**Fountain Inn, South Carolina
Regular Planning Commission Meeting
Thursday, August 3, 2023 - 6:00 PM**

RE: PF-2023-002

REQUEST: Final Development Plan for Barton Hollow

RE: Barton Hollow Final Development Plan Staff Comments – PF-2023-002

Site
Plan Overall

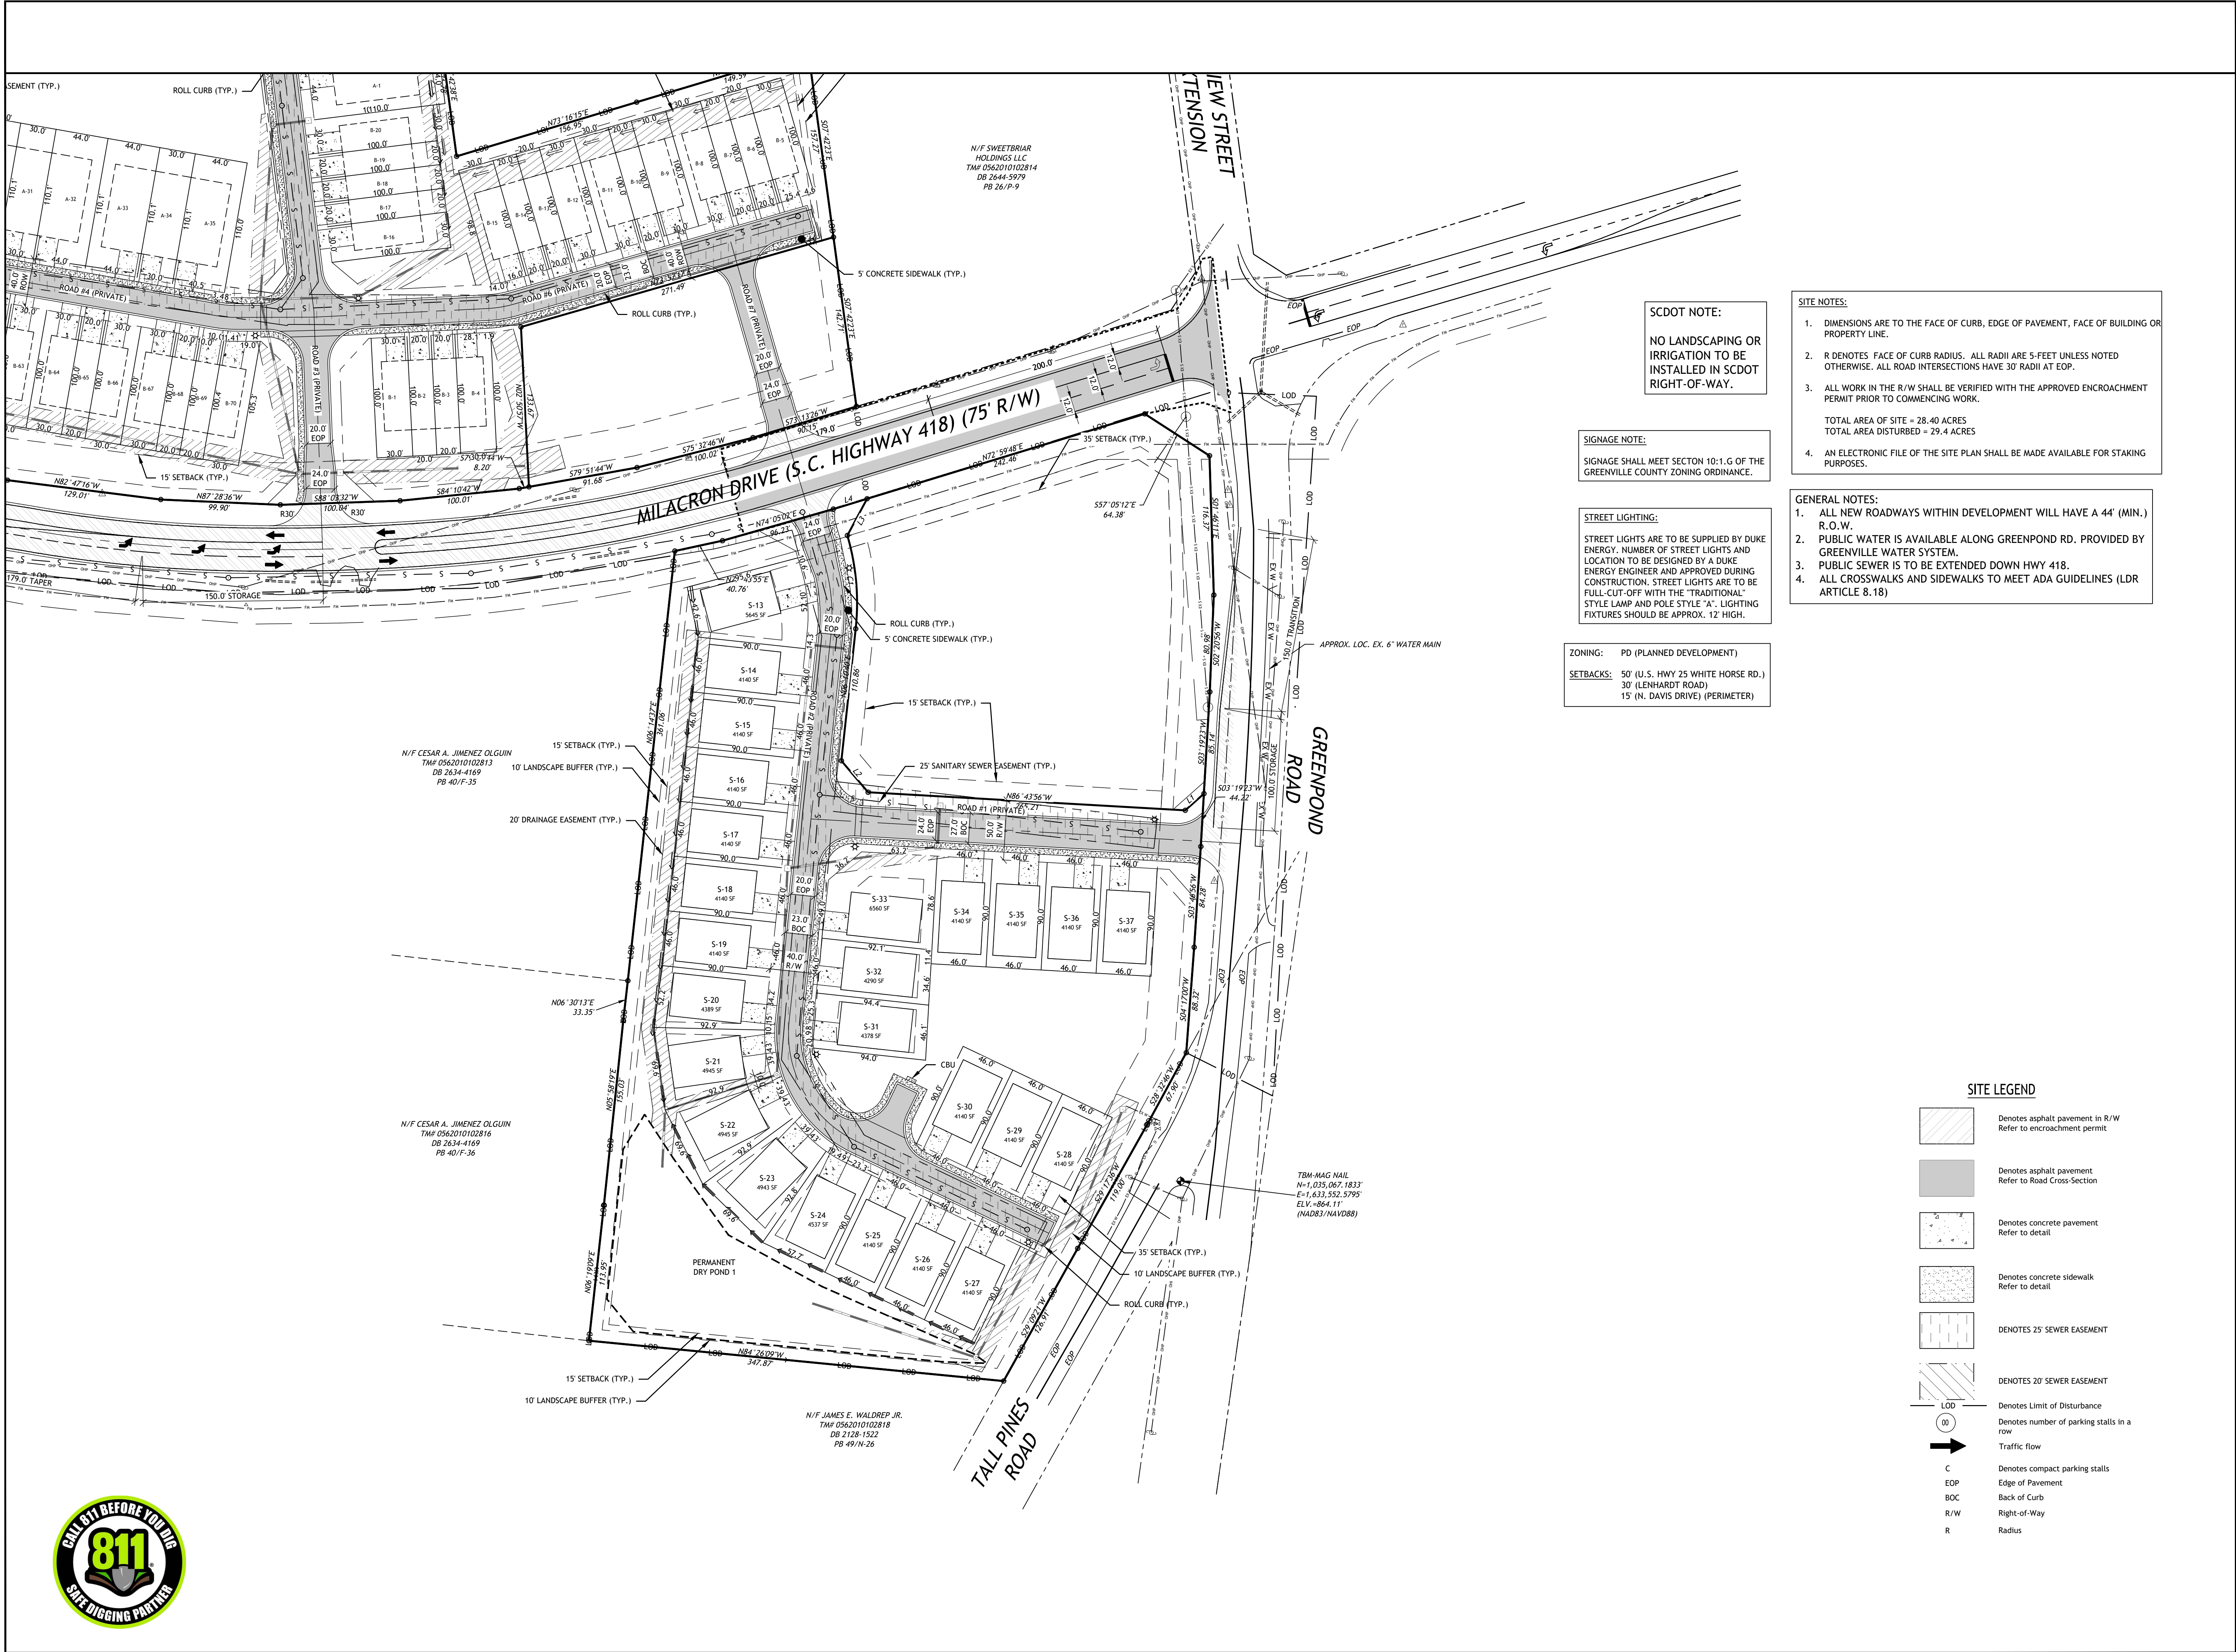
EXISTING CONDITIONS:	The site is wooded and sloped and is bisected by wetlands. The wetlands have been delineated and buffers are shown around them.
PROPOSED LAND USE:	The applicant is proposing single-family residential land use (attached and detached) and commercial land use. The commercial areas on TMS# 0562010102801, 0562010102823, and 0562010102820 are not included in this request.
DENSITY:	The Statement of Intent (SOI) states that the project density is 142 units and indicates that units are a mix of attached and detached single-family units. The Final Development Plan (FDP) shows 105 single-family attached units and 37 single-family detached units, which is consistent with the SOI.
LANDSCAPING AND OPEN SPACE:	The SOI indicates that approximately 9.13 acres of the 28.94 total site acreage will be preserved as open space and buffers. The FDP shows 11.3 acres preserved as open space and buffers. A 10-foot buffer will be provided around the perimeter of the site. The Preliminary Development Plan includes a dog park, community garden, gazebo and community gathering area, tot lot and community park, and another gazebo and community gathering area with a fire pit. These items are not shown on the FDP.

ROADS AND TRAFFIC:	The SOI states the primary circulation within the project will be new private roads which are shown on the FDP. For the north side of the development, there are two accesses on Highway 418 (Milacron Drive). The south side of the development will have entrances on Highway 418 (Milacron Drive), Greenpond Road, and Tall Pines Road.
PEDESTRIAN ACCESS:	In the FDP, a sidewalk is shown on one side of each proposed road within the development except for Road 7. The SOI states that open space may consist of walking trails; none are shown on the FDP.
CONCLUSION:	The subject parcels, zoned PD, Planned Development District are located on Highway 418 (Milacron Drive). City Council approved the annexation and rezoning of the subject parcels from C-2, Commercial District and Unzoned to PD, Planned Development District on March 9, 2023. The applicant did not include a sign plan, elevations, or a perspective sketch with the Final Development Plan submittal as required by Section 5:9.7.2 of the Zoning Ordinance. Staff is of the opinion that the request does not meet the requirements of the Zoning Ordinance.

STAFF RECOMMENDATION:	Based on these reasons, staff recommends denial of the Final Development Plan for Barton Hollow.

1. Per Section 5:9.7.2 of the Fountain Inn Zoning Ordinance (FIZO), an additional Final Development Plan will be required for commercial parcels unless further detail is provided.

1. Per Section 5:9.7.2.H of the FIZO, a sign plan is required.
2. Per Section 5:9.7.2.O of the FIZO, elevations of the proposed development are required.
3. Per Section 5:9.7.2.P of the FIZO, a perspective sketch indicating colors and materials is required.
